ATTN: Document Control Desk  
U. S. Nuclear Regulatory Commission  
Washington, DC 20555-0001**SUBJECT:**Beaver Valley Power Station, Unit No. 2  
Docket No. 50-412, License No. NPF-73Response to Request for Additional Information Related to Beaver Valley Power Station  
Unit No. 2 Spent Fuel Pool Rerack License Amendment Request (TAC No. ME1079)

Response to March 19, 2010 NRC Request for Additional Information Related to Beaver Valley Power Station Unit No. 2 Spent Fuel Pool Rerack License Amendment Request

Response to March 19, 2010 NRC Request for Additional Information  
Related to Beaver Valley Power Station Unit No. 2  
Spent Fuel Pool Rerack License Amendment Request  
Page 1 of 26

INTERIM FUEL LOADING CONDITION

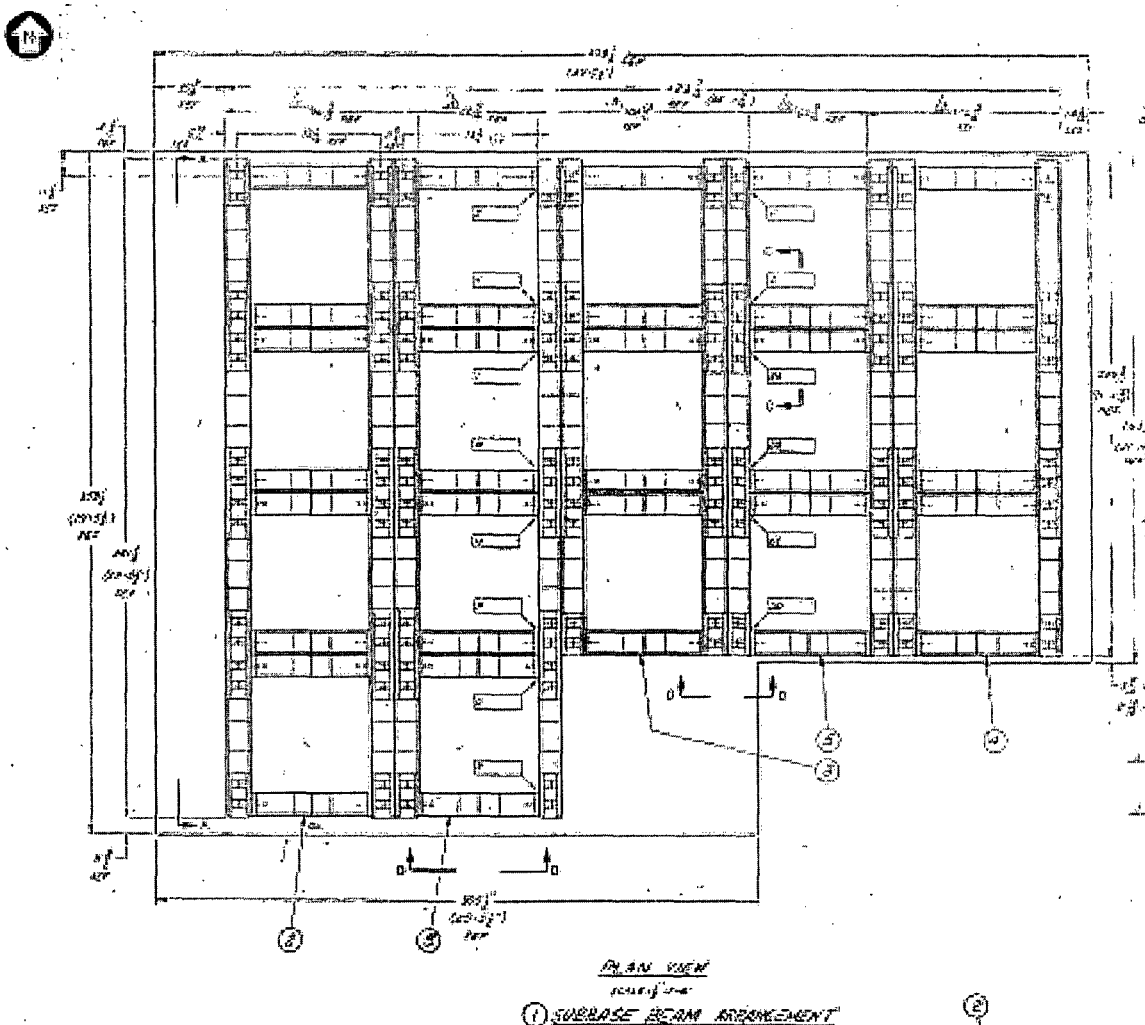
- 3. Page 5-22 of Enclosure C of Reference 1 indicated that all seven simulations performed for the proposed re-rack of the BVPS-2 SFP modeled fully-loaded racks. Page 5-8 of Enclosure C of Reference 1 indicated that partially-loaded racks can be modeled within DYNARACK. Given that interim conditions will exist in which the BVPS-2 SFP is partially-loaded with various rack configurations, provide a justification that the fully-loaded rack condition induces the most limiting conditions with respect to the seismic analysis and the structural adequacy of the SFP, the SFP liner, the SFP racks, the SFP cask pit, and the SFP cask pit platform.**

In general, the fully loaded rack condition is limiting because it maximizes the vertical compressive load and the horizontal friction force on rack support pedestals, and it tends to produce the maximum rack displacements. Nevertheless, to insure that a partially loaded rack is not limiting, a new WPMR simulation has been performed for the interim condition shown in the figure below (cross hatched areas indicate loaded cells).

The results of the new WPMR simulation for the interim fuel loading condition, along with the maximum results from the fully loaded simulations (that is, Run Nos. 1, 2, and 3 in Enclosure C of Reference 1), are summarized in the following table:

The above table shows that the results for the interim fuel loading condition are bounded by the results for the fully loaded rack condition. Furthermore, the maximum stress factor, the maximum pedestal vertical load, the maximum pedestal shear load, and the maximum fuel to cell impact force for the interim fuel loading condition are associated with racks C3 and D1, which are the only fully loaded racks in the interim fuel loading condition (see figure above). This demonstrates that the most severely loaded racks are the ones that hold the most fuel assemblies. Thus, the fully-loaded rack condition is the limiting condition with respect to the seismic analysis and the structural adequacy of the SFP, the SFP liner, the SFP racks, the SFP cask pit, and the SFP cask pit platform.

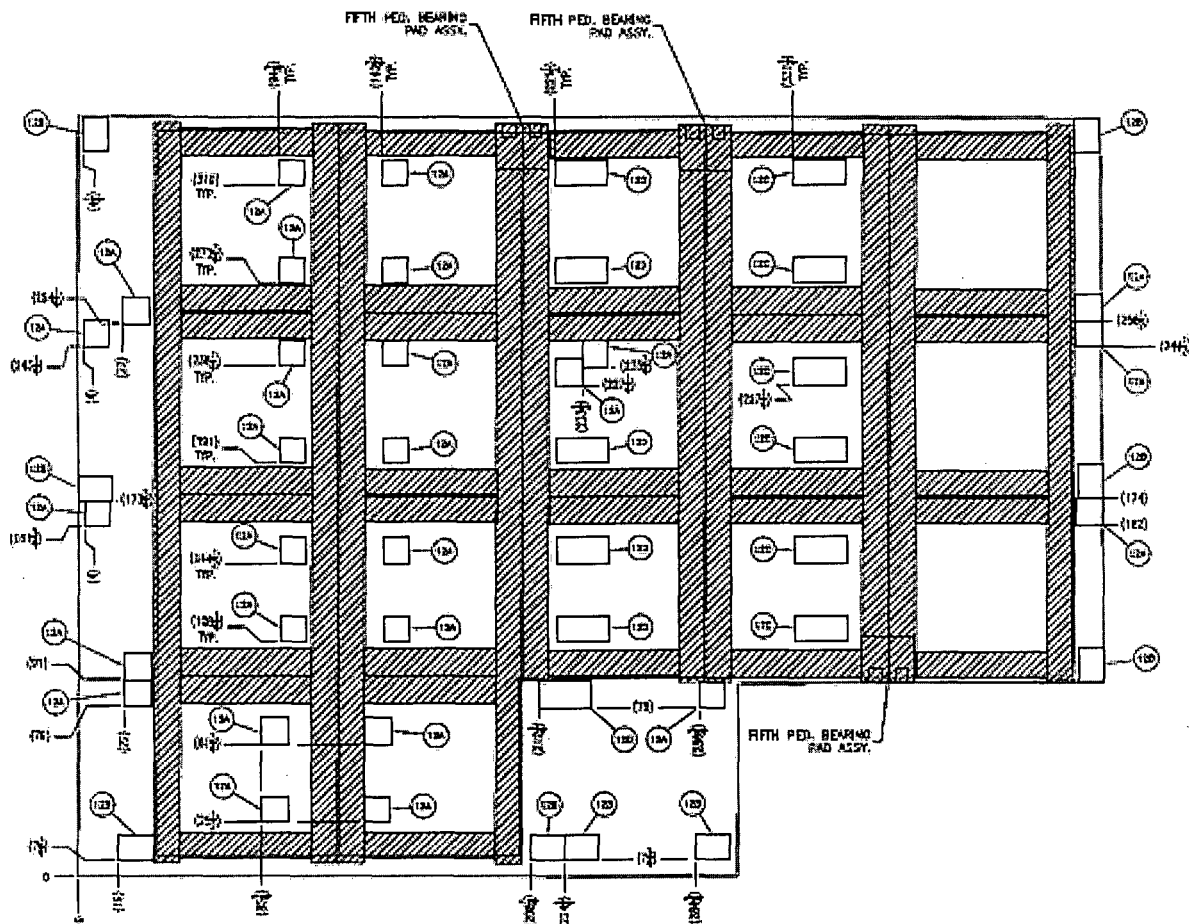
14. Section 5.8 of Enclosure C in Reference 1, "Bearing Pad Analysis," indicated that a number of the existing beam structures resting on the BVPS-2 SFP will be providing structural support to a few of the new racks. Please provide information relative to this beam structure (configuration, connection of rack to the beam (if any), load path to the supporting concrete floor, safety margins, etc.), such that a determination can be made regarding the structural adequacy of these beam structures.

The existing spent fuel racks installed in the BVPS-2 SFP are bolted down to a sub-base structure, which consists of a grid work of U-shaped beams. The following figure shows the general arrangement of the beams.

During the SFP re-racking, the existing racks will be unbolted and removed from the SFP. The sub-base structure, however, will remain in place.

The new spent fuel racks are designed as freestanding structures. The new spent fuel racks will not be secured to the sub-base structure. The size, number, and arrangement of the new fuel racks, including the individual support pedestal locations, have been carefully planned such that new spent fuel racks do not interfere with the existing sub-base structure, to the extent practicable. The following figure, which is excerpted from Reference 17, shows the locations of the support pedestal bearing pads relative to the existing sub-base structure.
